## 20A CHANGE NOTICE

This is a summary of changes made during production of Multiphase Exciter Model 20A. Some of these changes are applicable to Model 10B and are noted accordingly. This information is presented in accordance with Central Electronics' policy to keep its customers advised of improvements.

3-19-56 Rev.  
10B - 20A Change  
M139

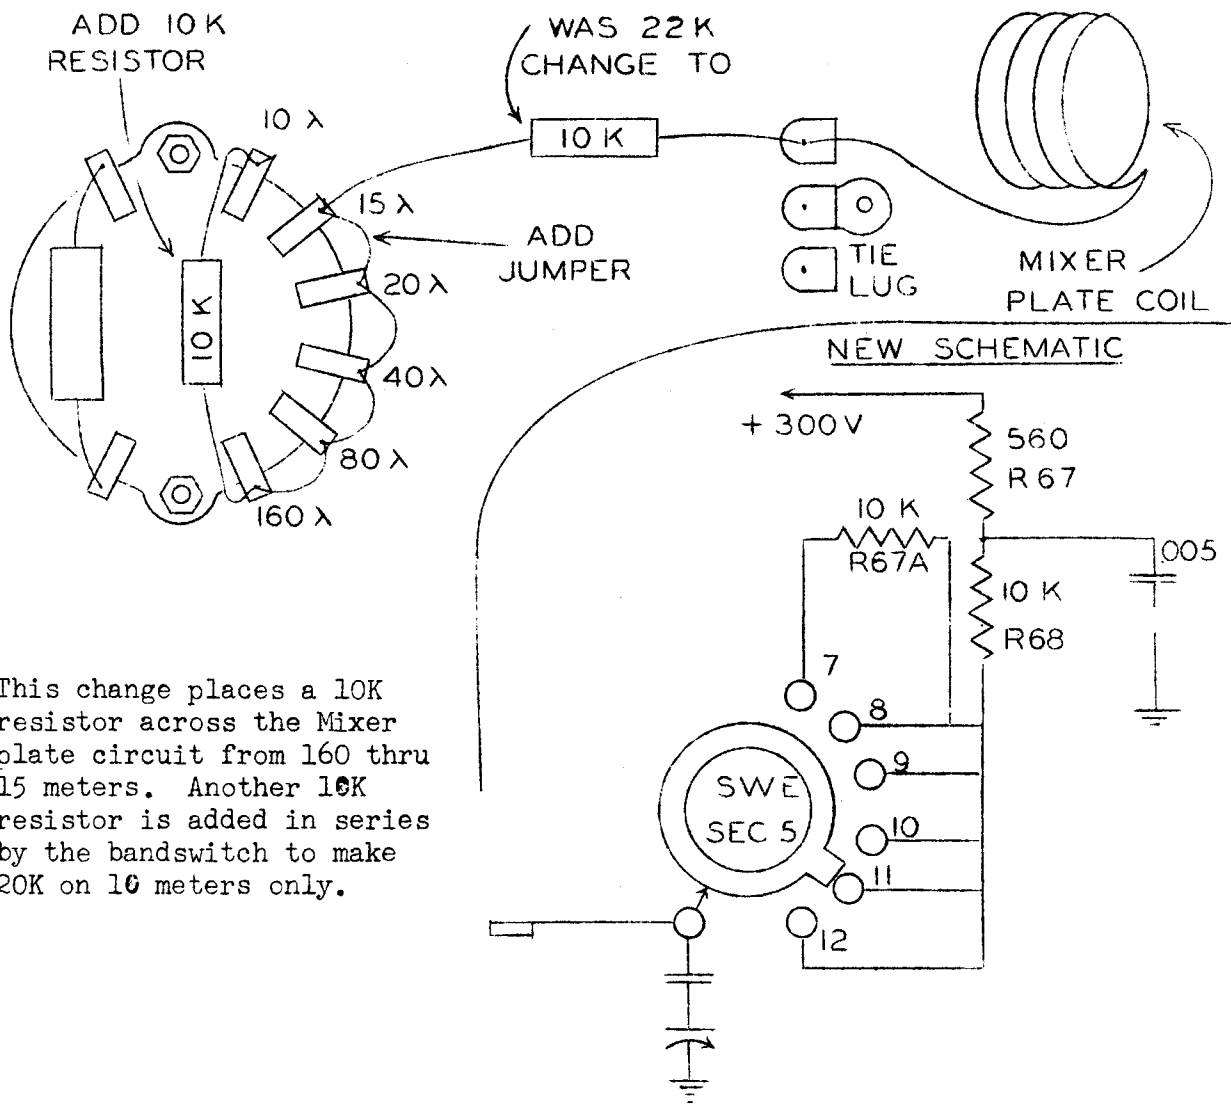
In the latter part of 1954 a bad batch of 6AG7 tubes was received from GE. The tube would develop control grid to screen shorts and burn out the 180 ohm series screen resistors R57 and R58. These resistors were removed and jumpers installed so the fuse would blow, instead of a resistor, if a tube shorted. Production switched to RCA type 6AG7 tubes with complete success.

20 A MIXER CIRCUIT CHANGE

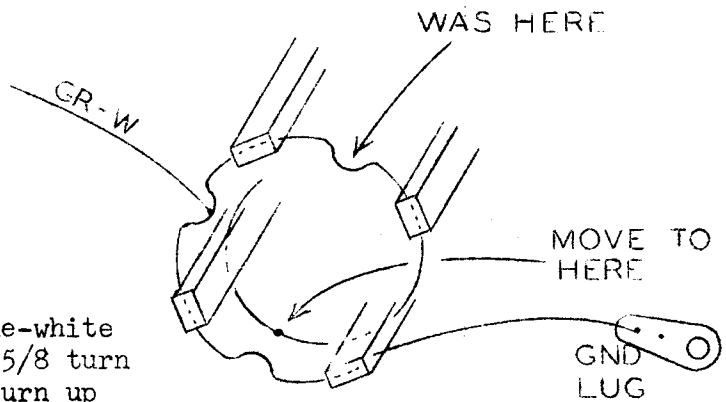
This change places a 10K resistor across the Mixer plate circuit from 160 thru 15 meters. Another 10K resistor is added in series by the bandswitch to make 20K on 10 meters only.

15 METER 6AG7 PLATE COIL CHANGE

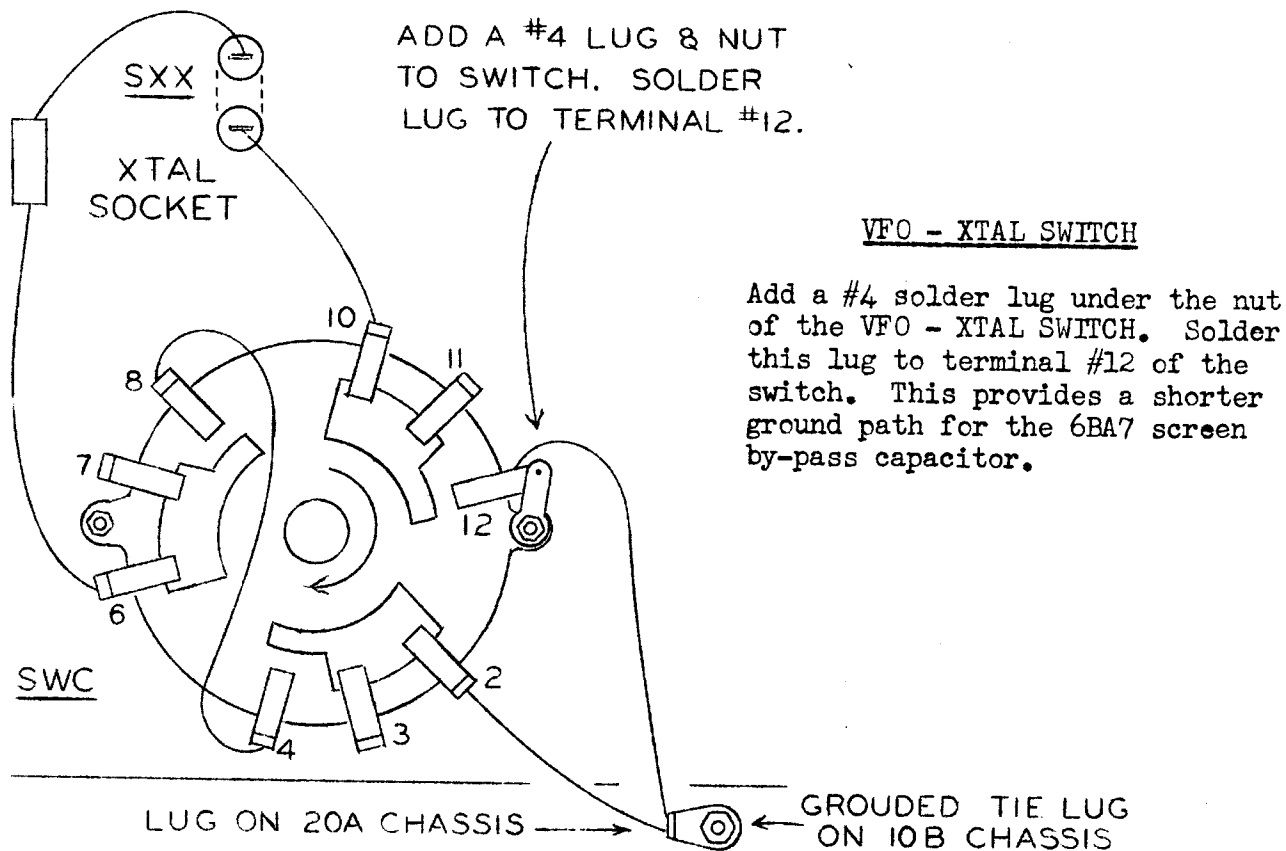
Change blue-white lead from 5/8 turn to 1-1/8 turn up from ground end.

VOICE CONTROL RELAY CIRCUIT CHANGE

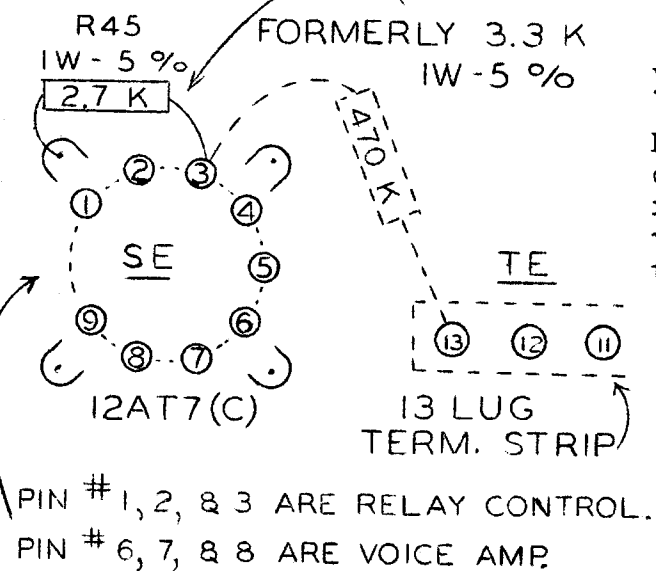
R45, in the cathode of the relay control tube, has been changed from 3.3K 5% to 2.7K 5% in order to lengthen the relay "hold-in" time and sensitivity. If the relay will not release after speaking into the mike, the value of this resistor should be increased.

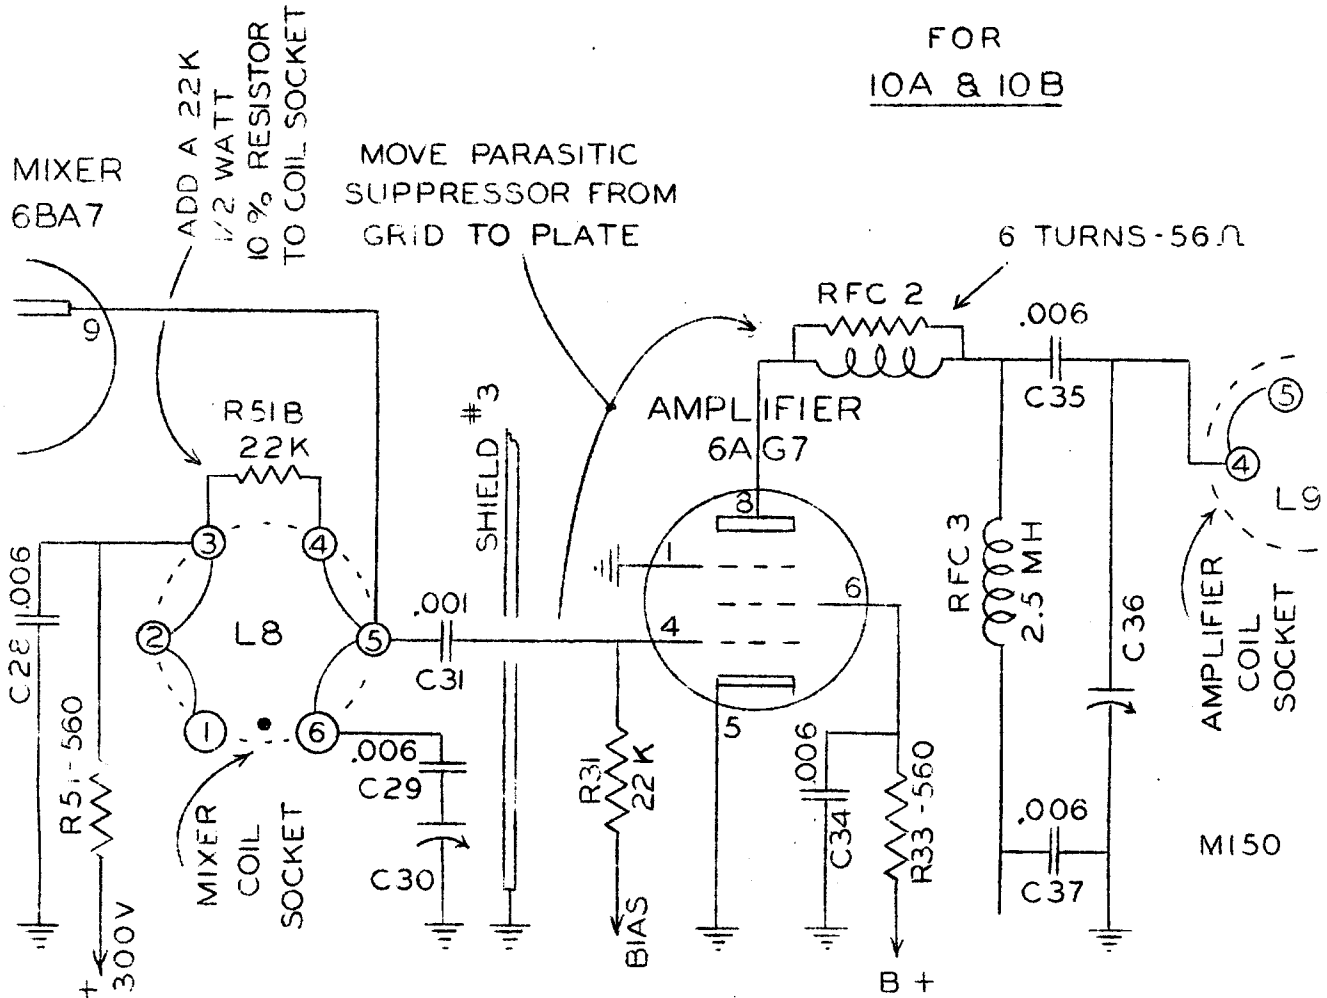
ADD A .006 MICA CAPACITOR FROM PIN No. 6 TO SOCKET GROUND LUG, AS SHOWN. THIS WILL REDUCE THE TENDENCY TOWARD PARASITIC OSCILLATION.
